USNRC APPLICATION
SUA-1341 License Amendment
Ludeman Project
Converse County, WY

June 2013

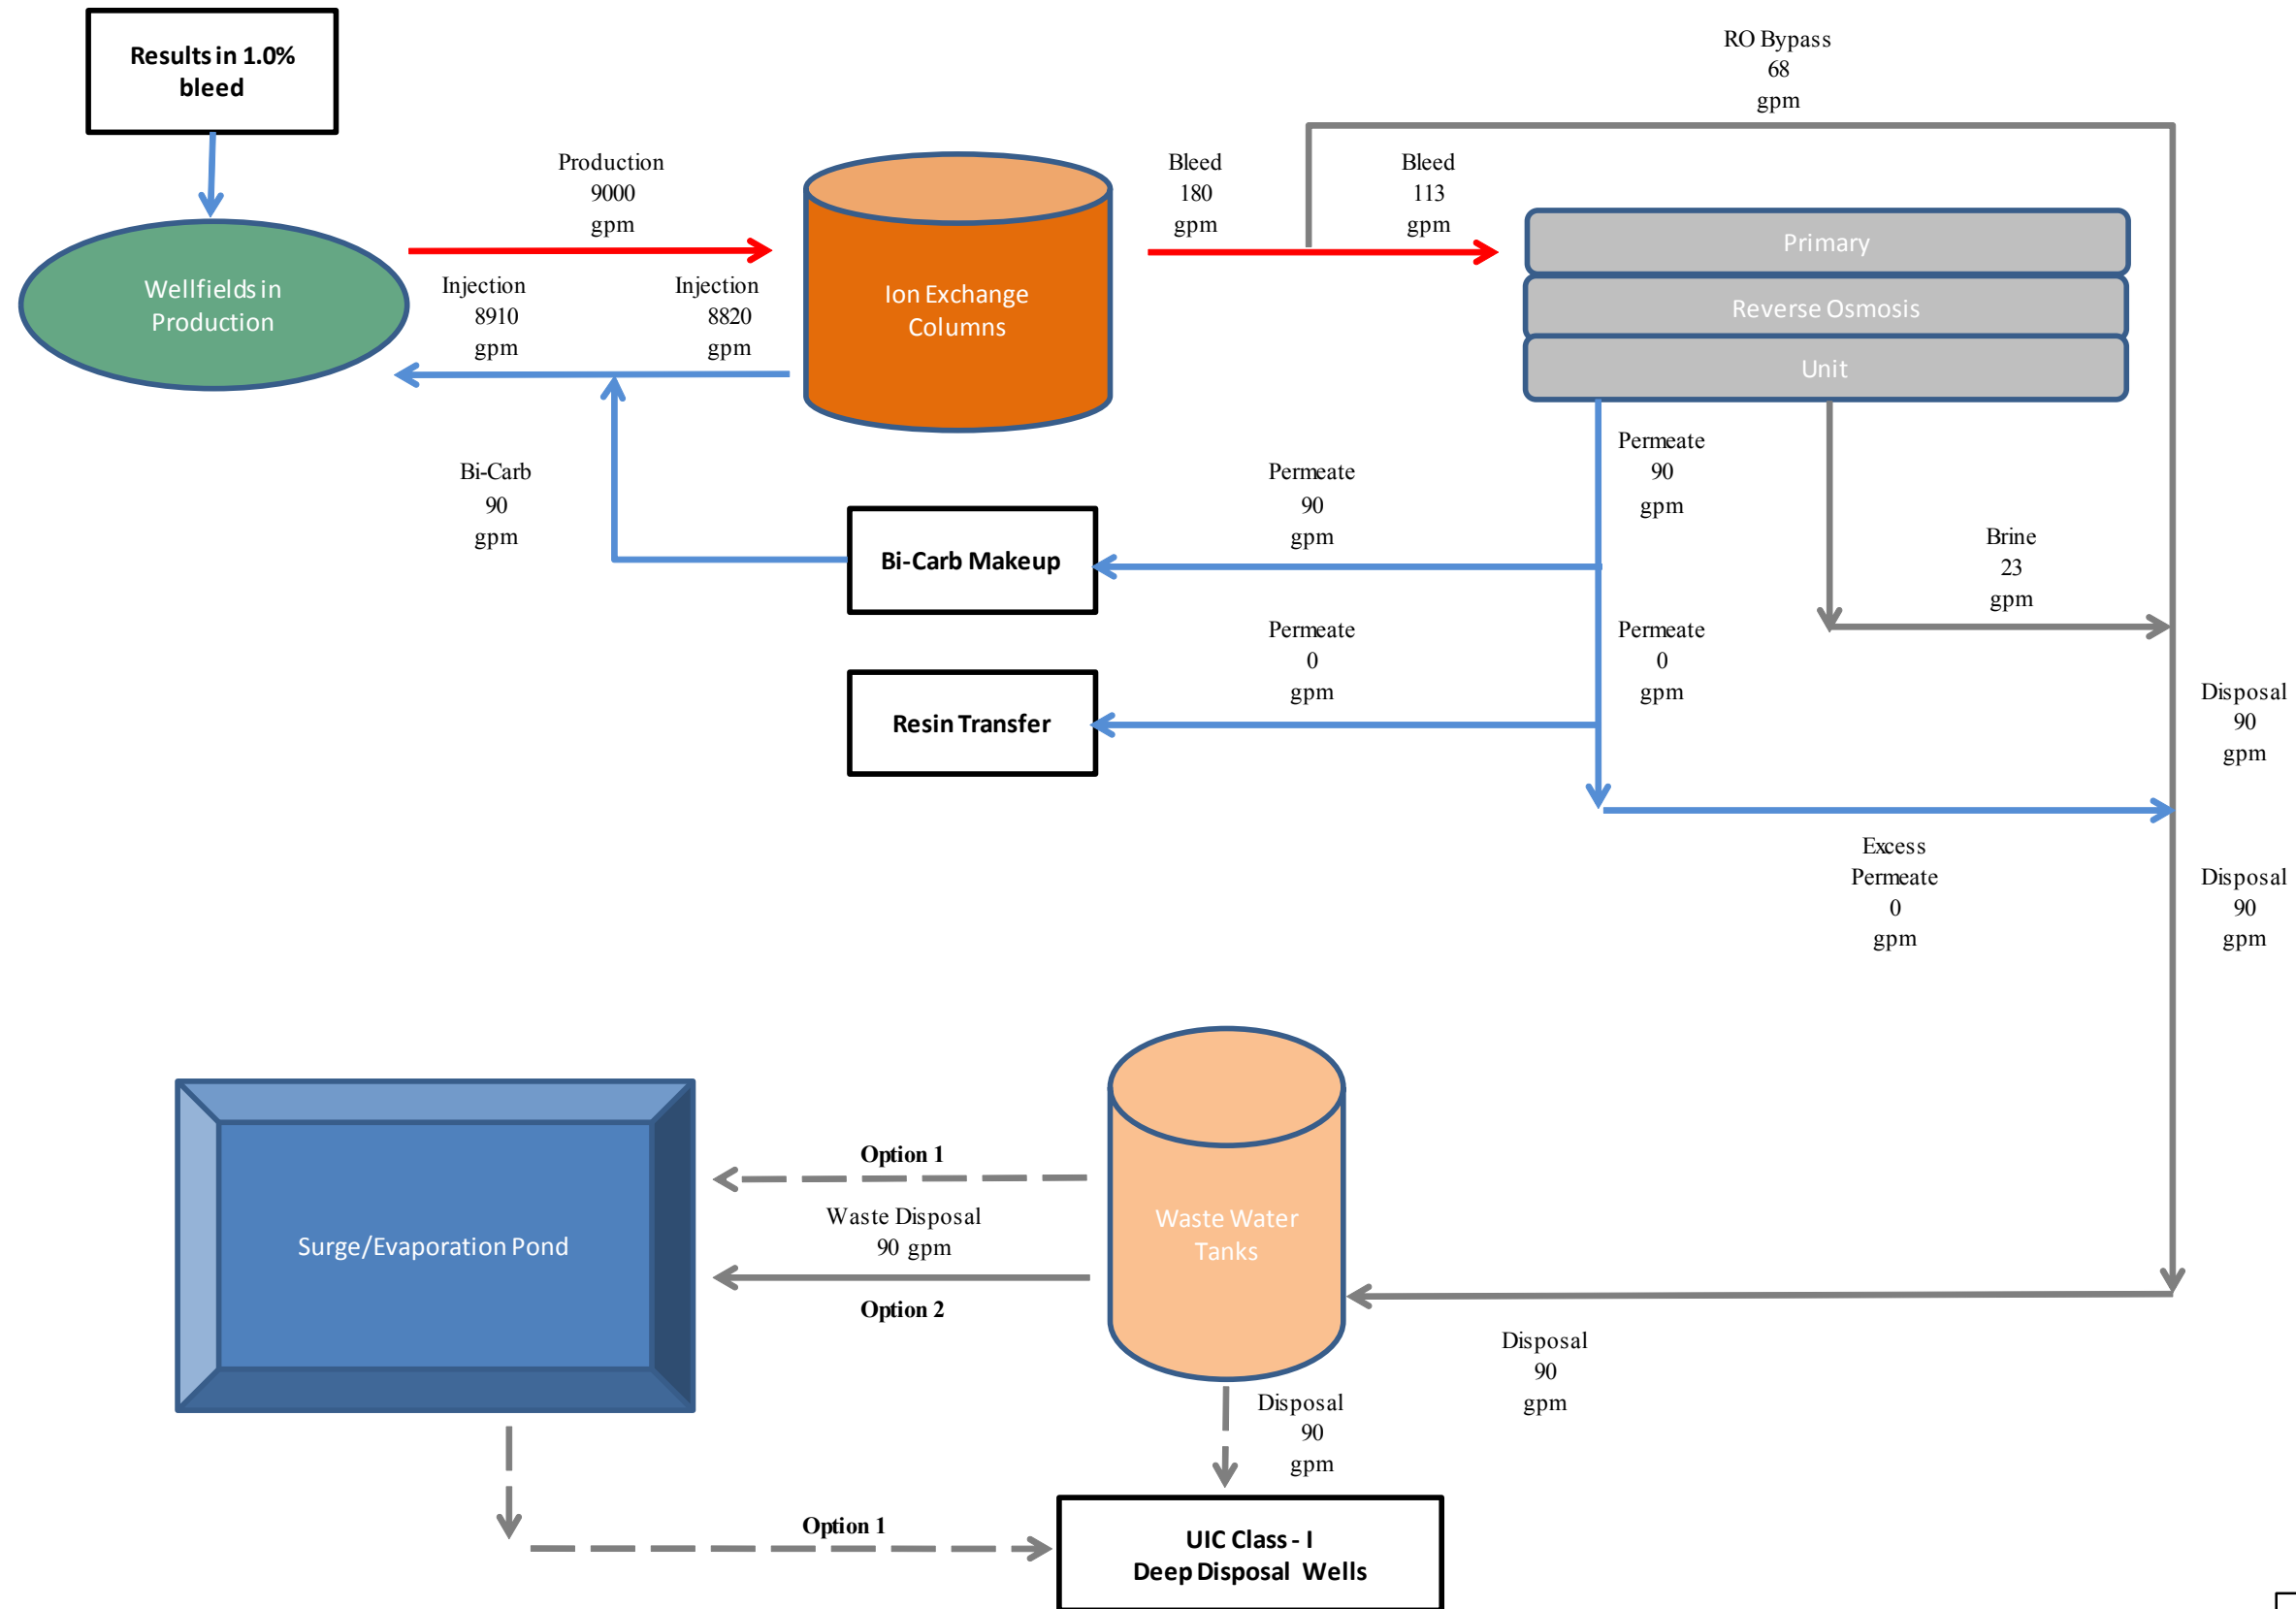
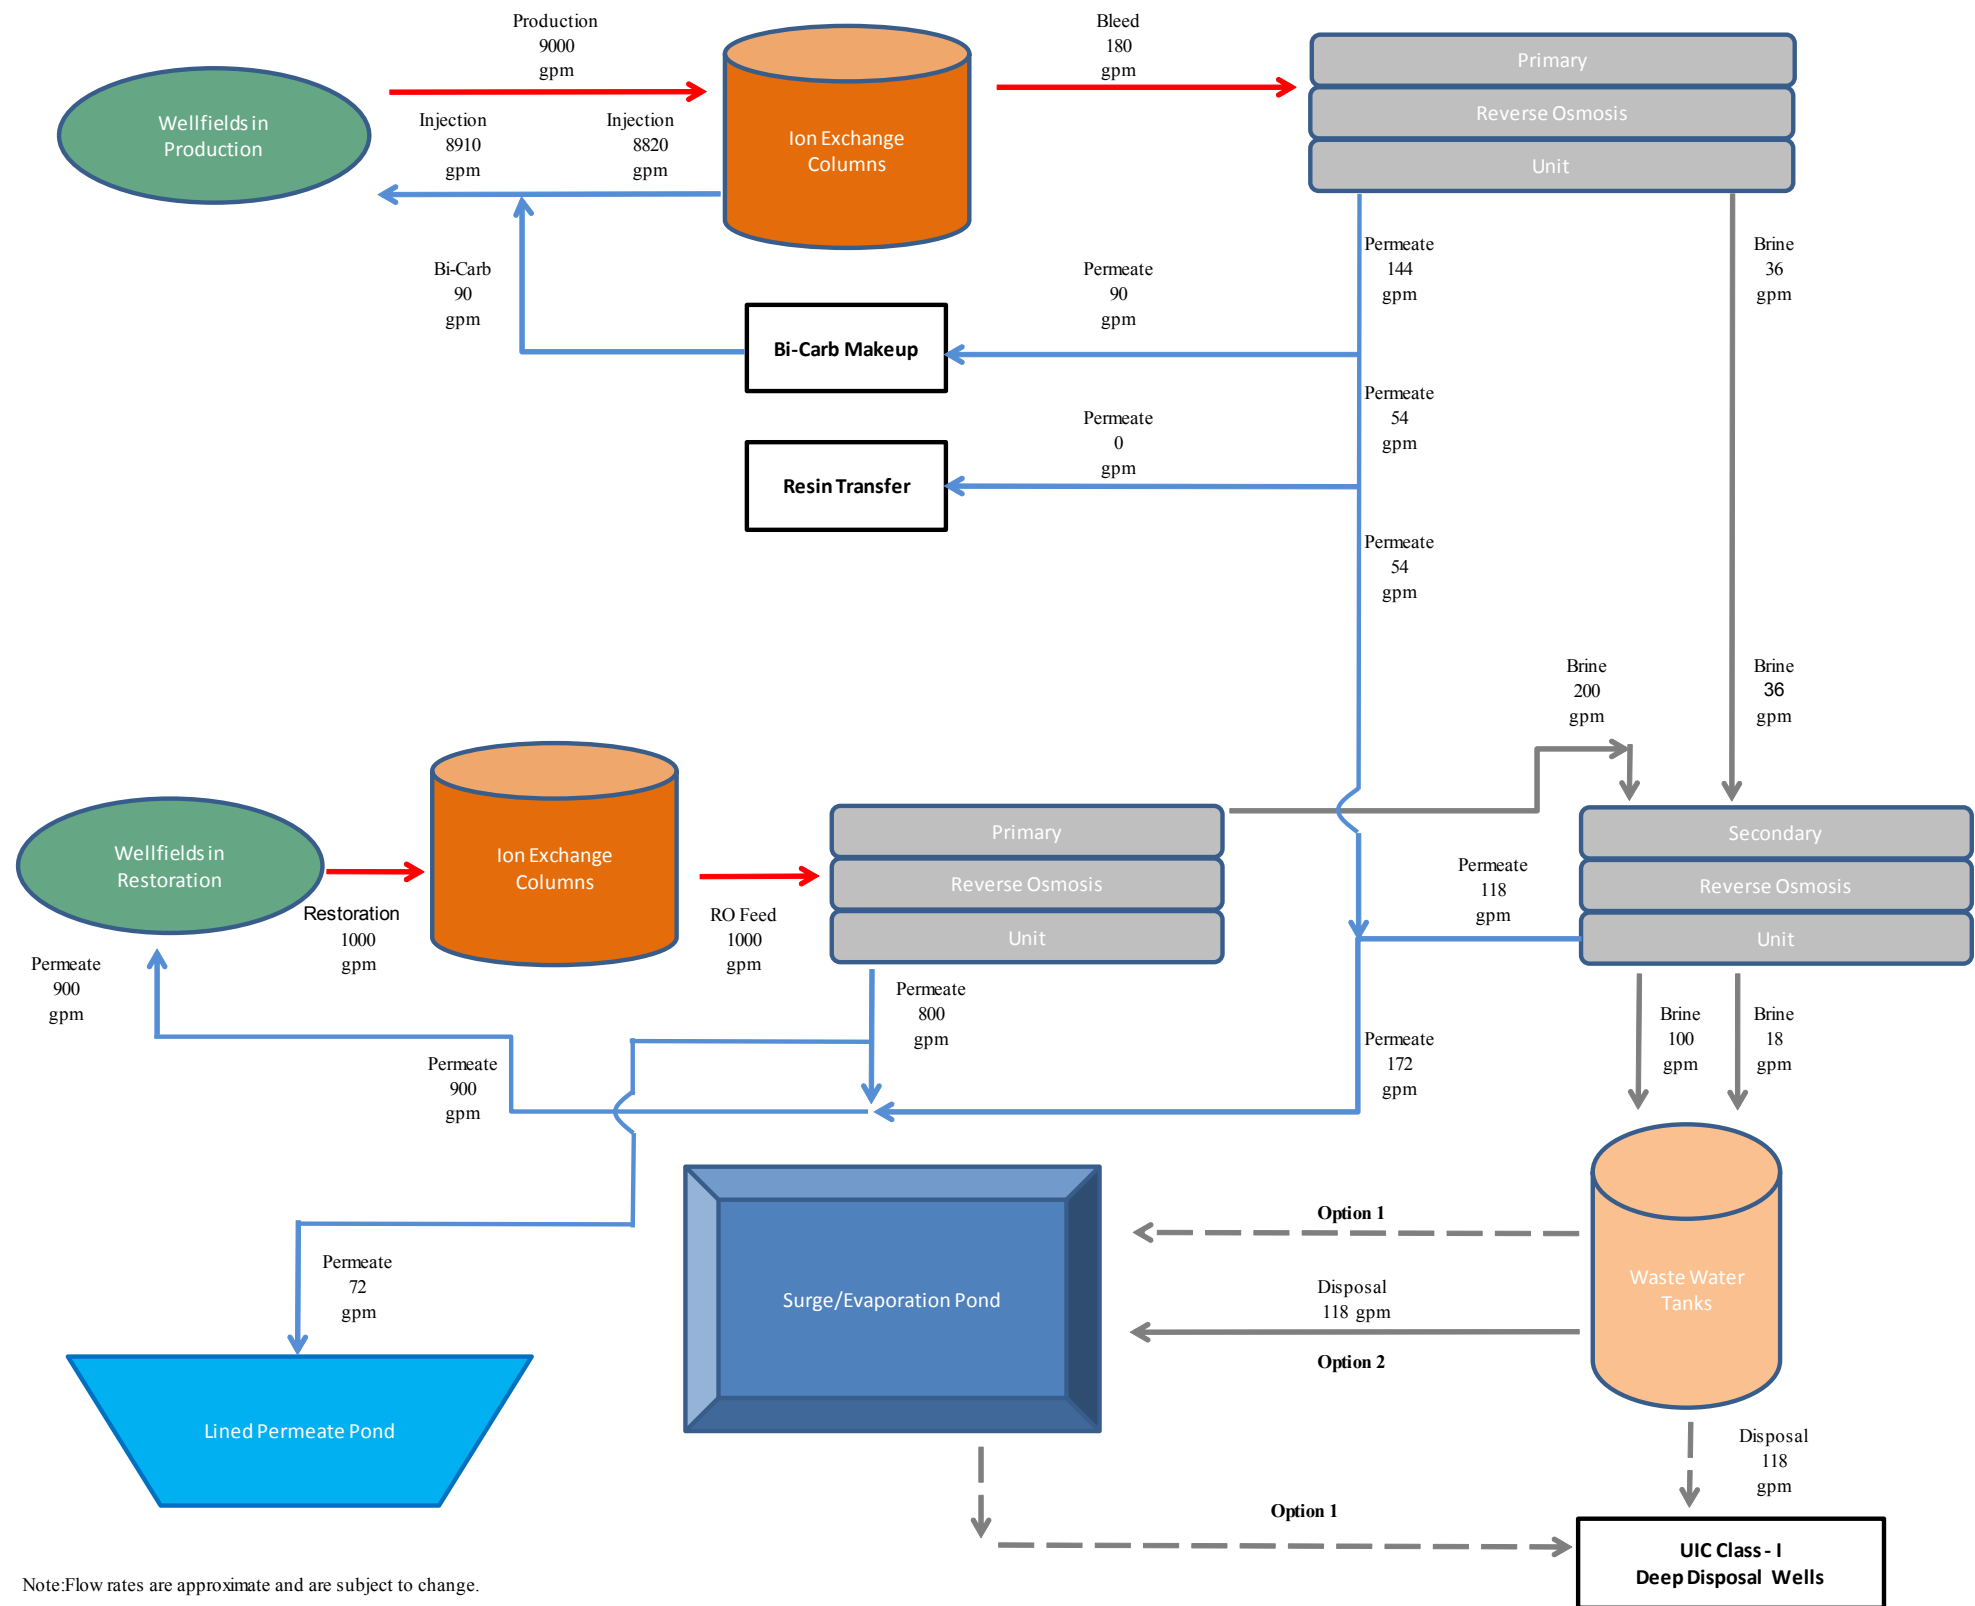
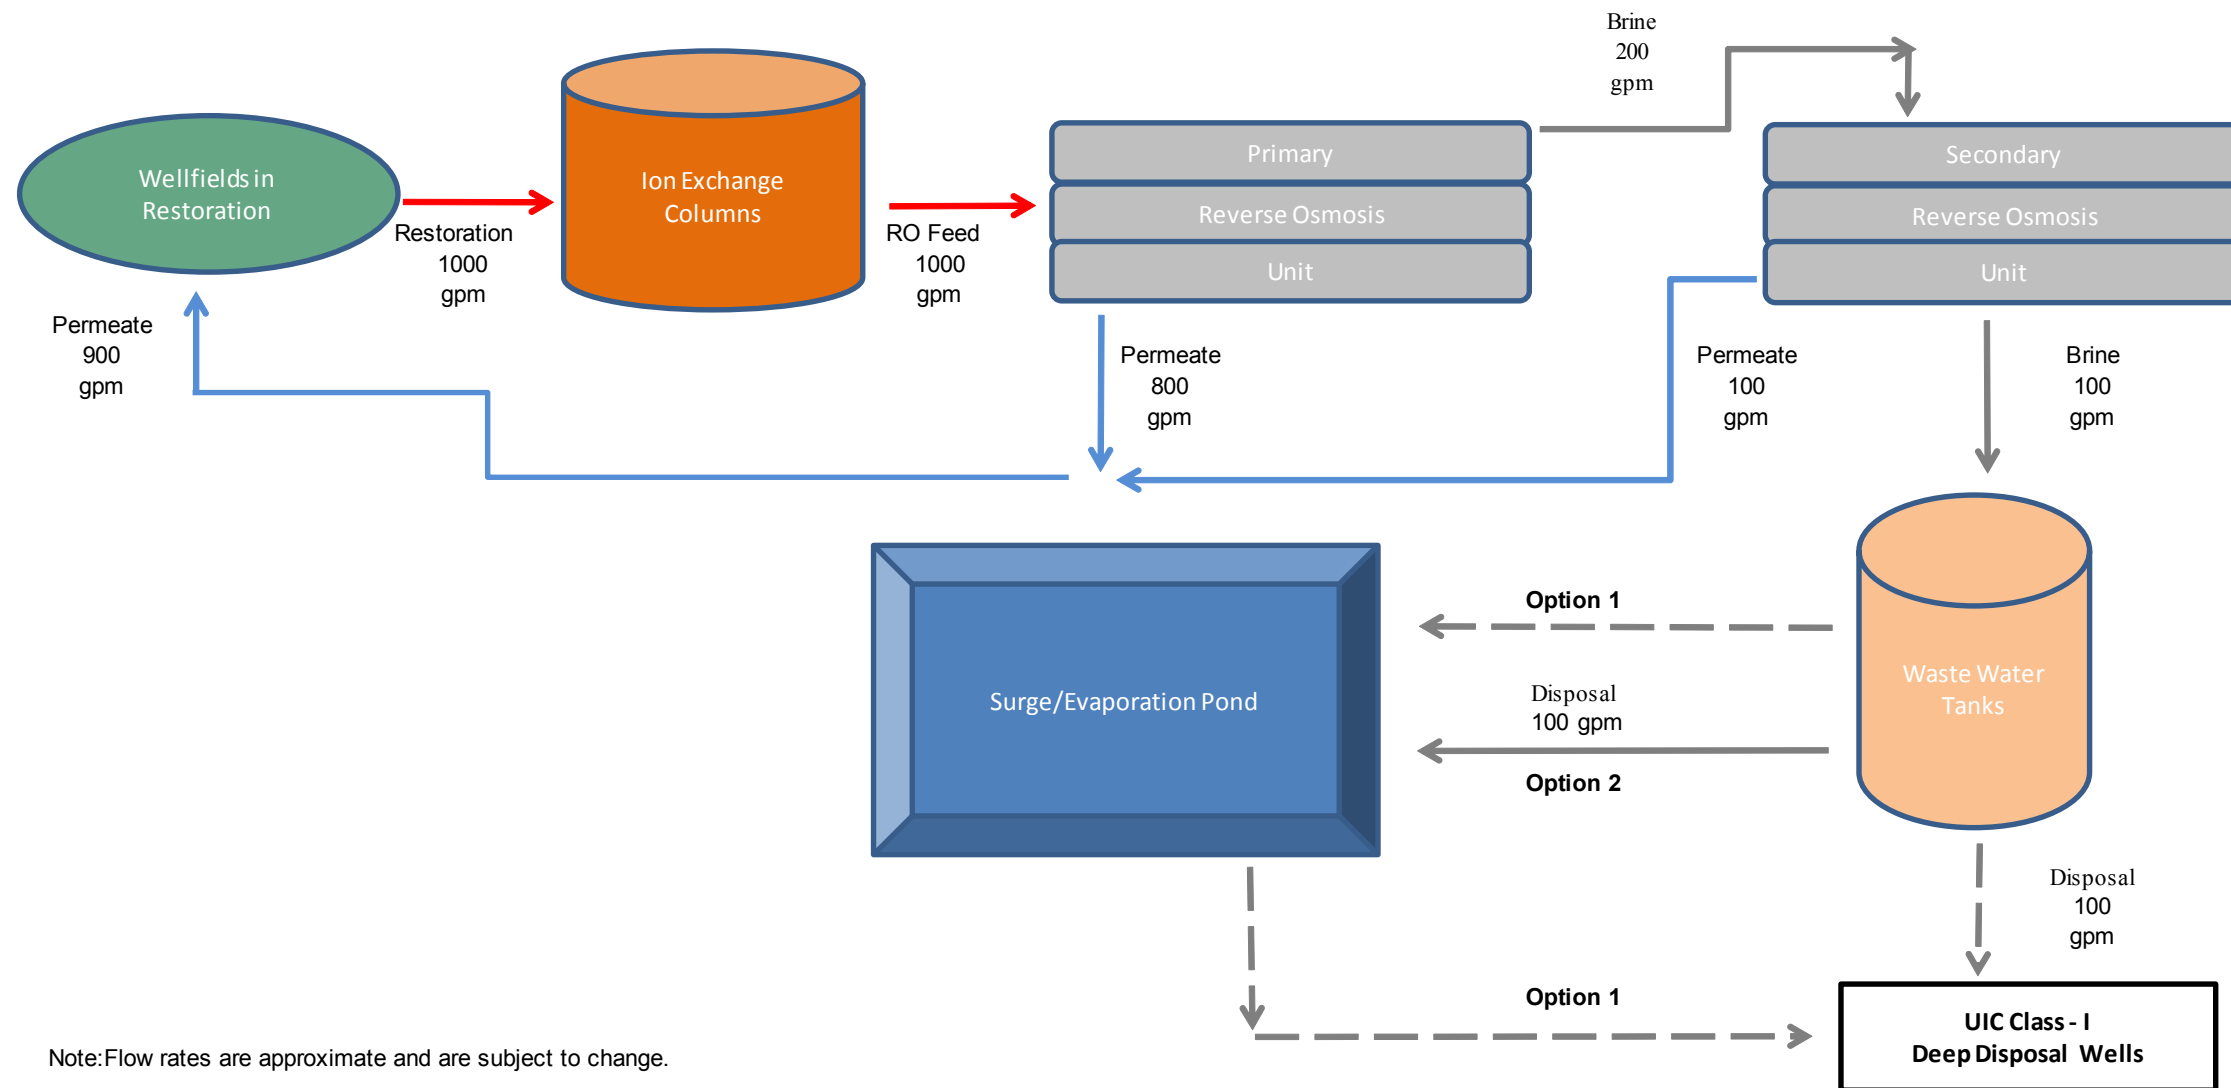
Please provide the water balance for each Project phase at each Satellite facility.

- A. Please modify Figure 3-6 of the TR to include reverse-osmosis treatment of bleed water and the flows of permeate and brine as components of the overall water balance.*
- B. Please address the potential for and volume of excess permeate during the first two years of operation before groundwater restoration begins (shown in Figure 1-4 of the ER) and clarify the proposed disposal method of this waste stream.*

Uranium One has developed new water balance figures and values to both reflect the current water balance flows and provide the NRC quantitative data in support of the environmental impact analysis. The following figures depict the water balance during all phases of the project and have been added to TR Section 4:
